TECHNICAL ADVISORY BULLETIN

Cleancut pump A2EA-6527

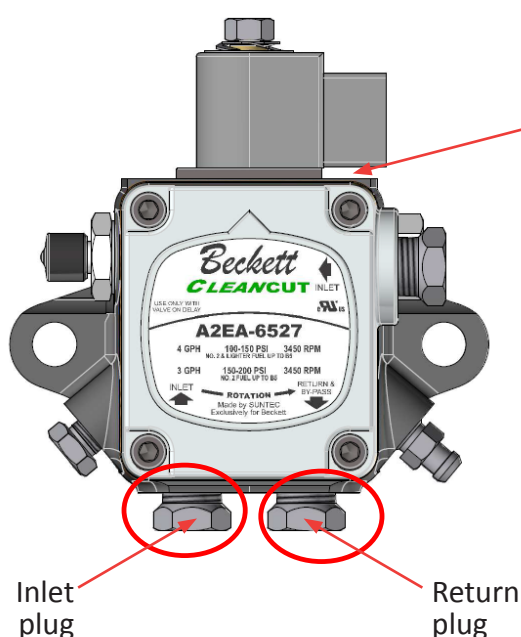
This bulletin advises that Cleancut pumps A2EA-6527 manufactured during months March, April and May 2016 might present a tightness issue on Inlet/Return 1/4-18 NPTF plugs.

In order to identify such pumps, it is necessary to check the date stamped on the top of the body :

Date code : **MMDDYY**
(112216 = Nov. 22, 2016)

1. Before starting your burner, confirm the pump is not in the affected date range. If the unit is in the date range, follow steps 2 and 3.
2. Carefully verify the tightness of Inlet/Return plugs.
3. For any recognized or suspected leak, unscrew plugs and apply pipe sealant, and re-insert them with a fitting torque of 12 to 20 Ft.Lbs.
